TO: Planning Commission

FROM: Olivia Dias, Current Planning Manager for
Lisa Anderson-Ogilvie, AICP
Deputy Community Development Director and
Planning Administrator

SUBJECT: **Tentative Subdivision and Class 2 Adjustment No. SUB-ADJ21-05 – 2230
Doaks Ferry Road NW; Open Record**

Written Rebuttal to Applicant's introduction of new evidence into the hearing before the Planning Commission during his rebuttal to the testimony in the appeal of the Planning Administrator's approval of **Case No. SUB-ADJ21-05 (2230 Doaks Ferry Rd NW)**

**LOT GRADING &
TREE CONSERVATION
PLAN**

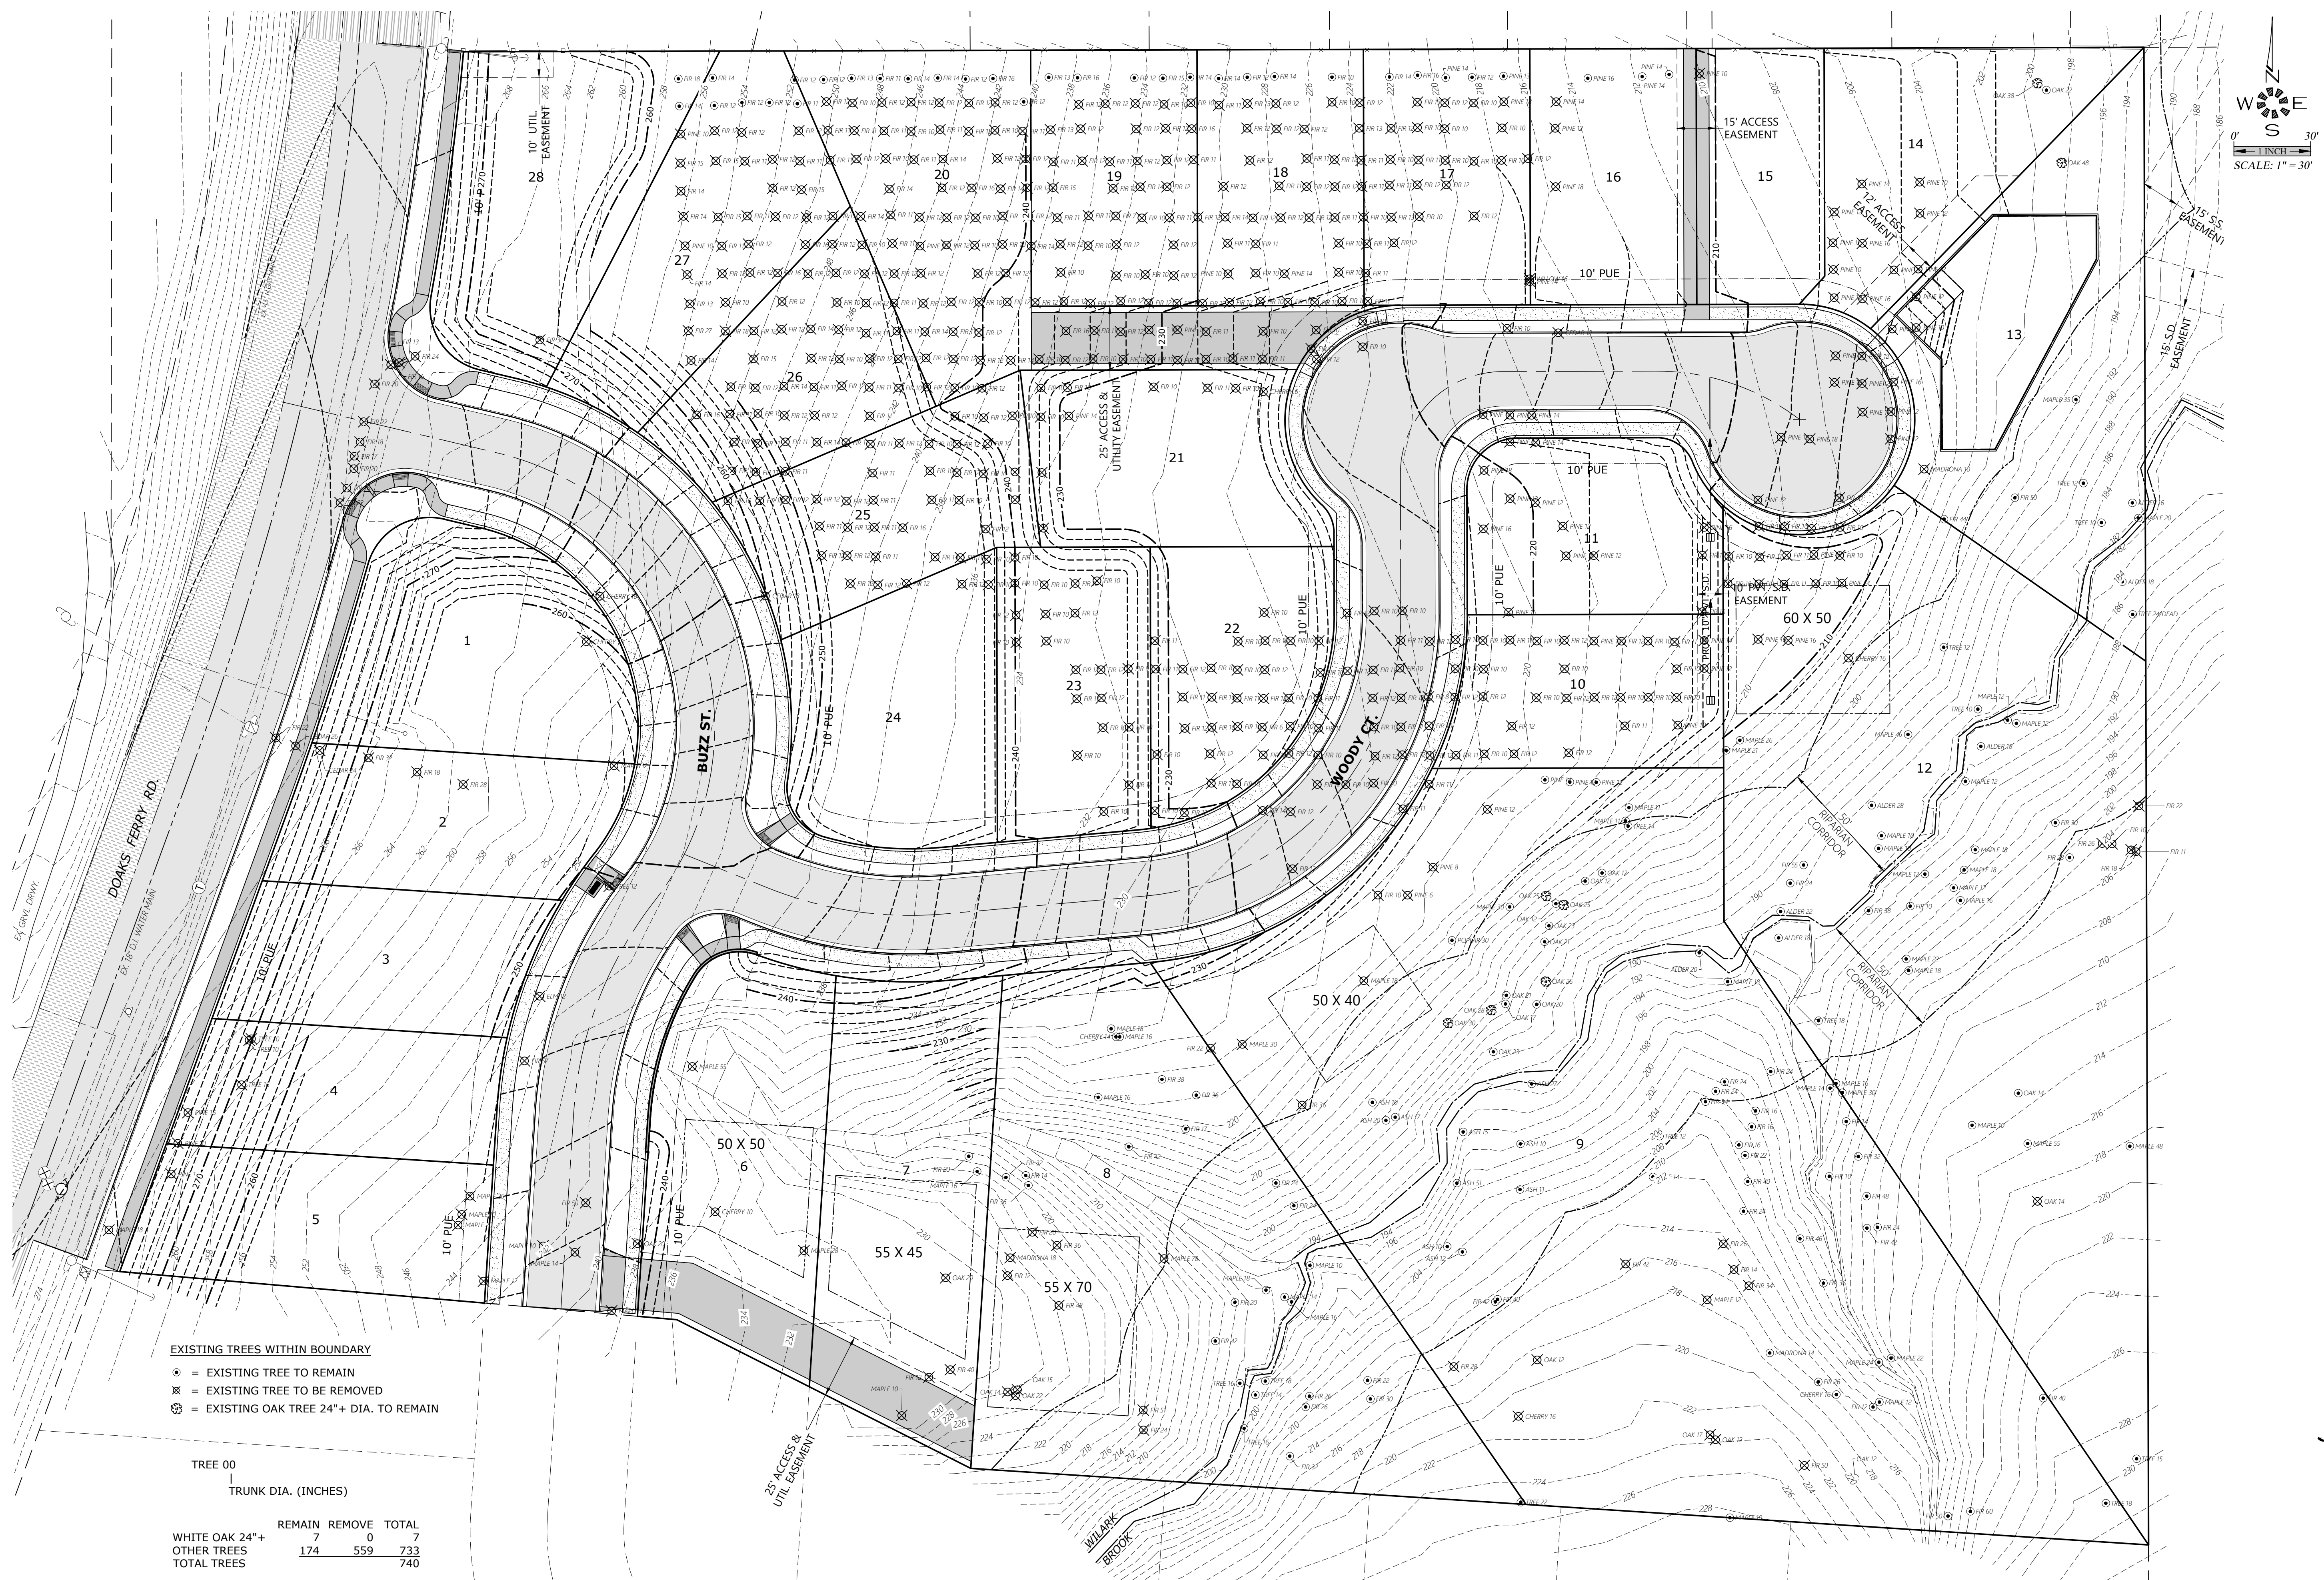
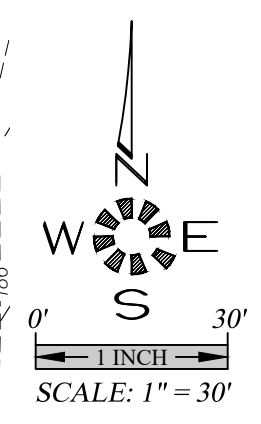
Appellant’s contend the topographic features depicted on Applicants lot grading and tree preservation plan are waterways which must be depicted on the application, together with their associated riparian corridors. The two topographic depressions have not been designated as a waterway by the Director as required by SRC 808.005, are not reflected as a drainage way on the most recent USGS maps, and are not reflected on any available on-line source reviewed as a waterway. Riparian Corridors are defined in SRC 111.001 as “area adjacent to a waterway”. As the

The application materials contain all the required information. Applicant’s lot grading and tree conservation plan reflects the topographic features on the site, and depicts Wilark Brook and the riparian corridor along Wilark Brook, as well as topographic features to the west and east of Wilark Brook, which direct any surface water on the site into low areas, ultimately passing it to Wilark Brook. SRC 808.005 defines a waterway as “any river, perennial stream or creek within the city as designated by the Director.” Only Wilark Brook has been designated as a waterway. Accordingly, Applicant has depicted the only waterway on the premises, and the topographic information provided by Applicant reflects the topographic features which would direct water to low points and to Wilark Brook. Thus, the application identifies canals, ditches, and waterways on the property indicating as required by SRC 205.030(a)(10).

SRC 205.030(a)(11), further requires that the applicant identify natural features including creeks, drainage ways as shown on the most recent USGS maps, and wetlands as shown on the local wetland inventory. No portion of the property is reflected in the local wetland inventory.¹ The only drainage way shown on USGS maps is Wilark Brook, which is depicted on the lot grading and tree conservation plan provided by Applicant. Finally, because Applicant seeks an adjustment, SRC 250.005(c)(2)(d), requires that the information submitted identify drainage patterns and courses on the property. SRC 75.020 defines a drainage course as “any land surface, ditch, waterway, or other feature which serves as a course for the transmission of surface water and storm water.” As discussed above, Applicant’s lot grading and tree conservation plan depicts topographic low points on the property which would serve to transmit surface water to Wilark Brook. Accordingly, all required drainage patterns and courses are depicted.

Figure 1: Image from Salem Keizer Local Wetlands Inventory (1999)

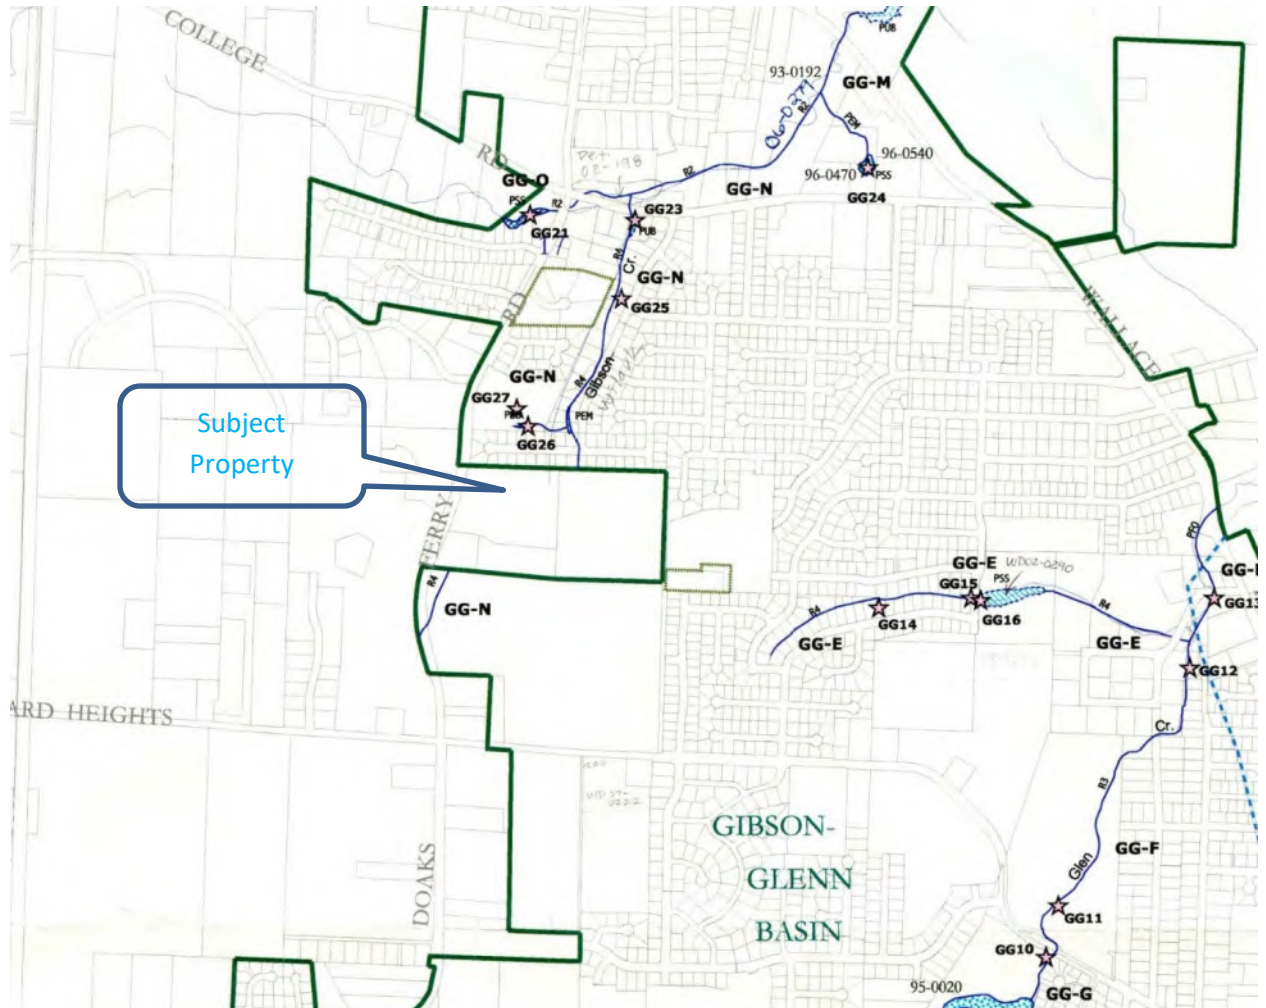
1. The application fails to identify two headwater streams tributary to Wilark Brook as required by SRC 205.030 (a) (10) and (11) *to locate waterways* (10) and SRC 250.005 (c) submittal requirements *to locate natural features including creeks*.
2. The application does not include a wetland inventory. The subject property was outside the City as shown on the Salem Keizer Local Wetland Inventory that was conducted in 1999 (Figure 1).

This statement is in error since the subject property was not a part of the 1999 Local Wetlands Inventory (Figure 1).

Figure 4: Map showing Tributary A

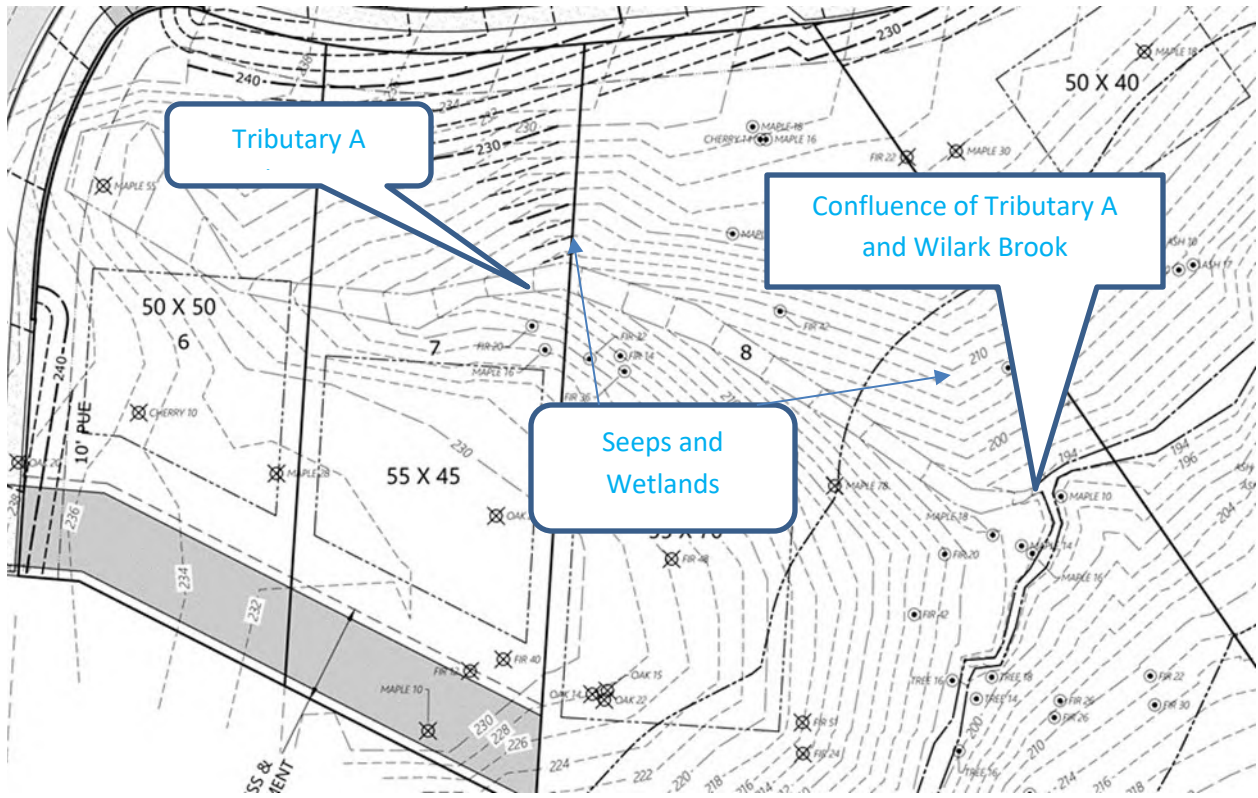
These two existing streams are not identified in the application. The designation of these streams and their 50-foot riparian corridors should be identified under the provisions SRC Chapter 808 and appropriate provisions made for their protection.

As shown in the application, the building envelope of Lot 6 fully occupies the riparian corridor of Tributary Stream A and the NE corner of the envelope extends directly into the stream. The building envelopes of Lot 7 and Lot 8 occupy the riparian corridor of Tributary Stream A and nearly extend into the stream.

Figure 7: Habitat Tree in the Riparian Corridor of Tributary B (photo 6/9/2021)

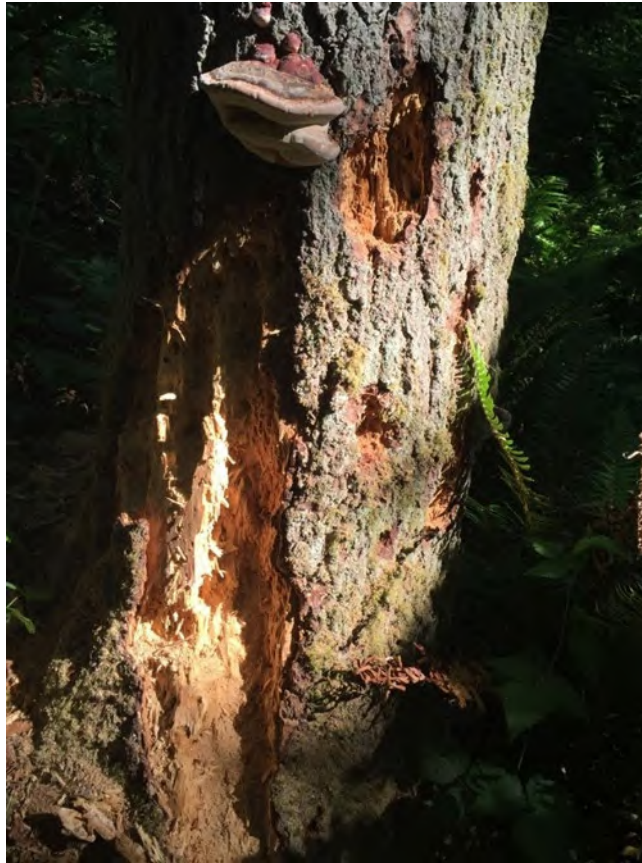
Other wildlife habitat values include the riparian cover to the tributary streams that help to maintain cool water in Wilark Brook and associated wildlife habitat such as the snag (Figure 7) providing habitat for cavity nesting birds and animals.
